Administrative Board of Review Meeting
Wednesday, October 1, 2025 - 4:00 PM
AGENDA

SITE PLAN COMMENT LETTER

Request: Approval of a final development plan by the ABR based on the submitted site and architectural plans for Cologix Building 1.

1 WEST ELEVATION
1/8" = 1'-0"

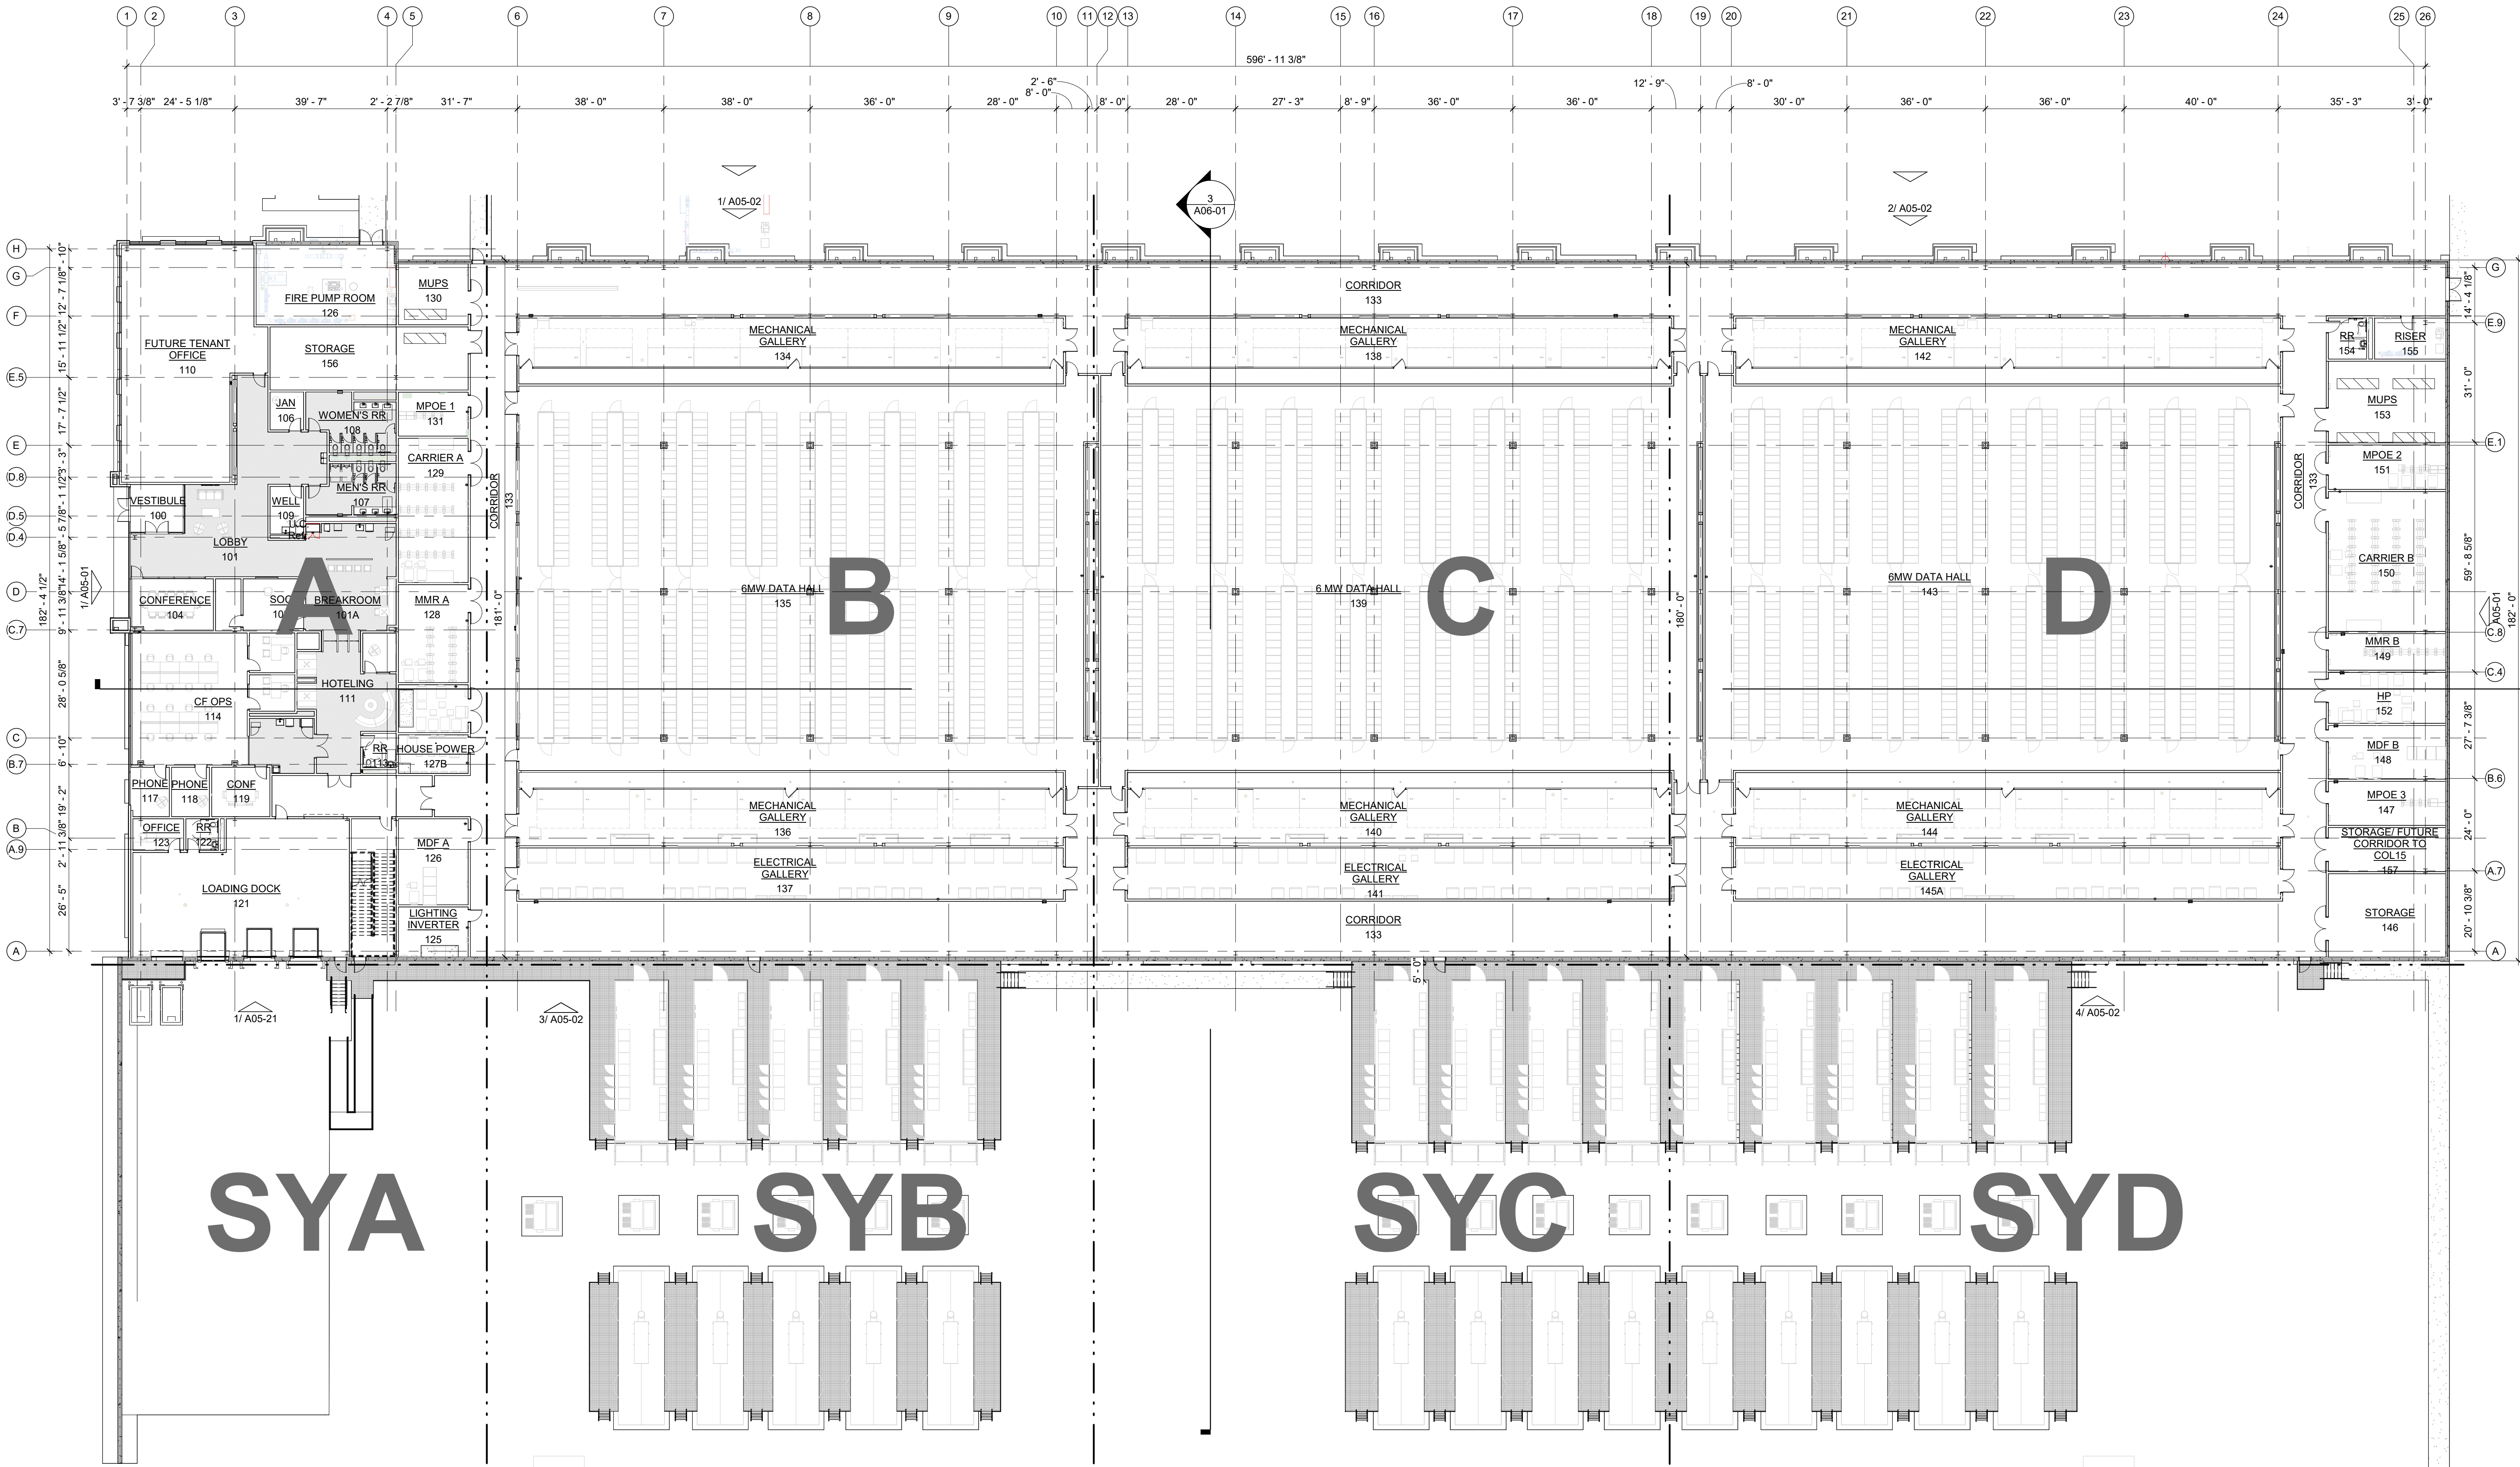
Reviewer Comment: Illustration 5.4.2 of the zoning text establishes photo references for Data Center architectural styles. While architectural review is subjective, the proposed building elevations use a mix of materials arranged in a way to break up long stretches of walls, and blend modern and traditional materials similar to the photos in the zoning text.
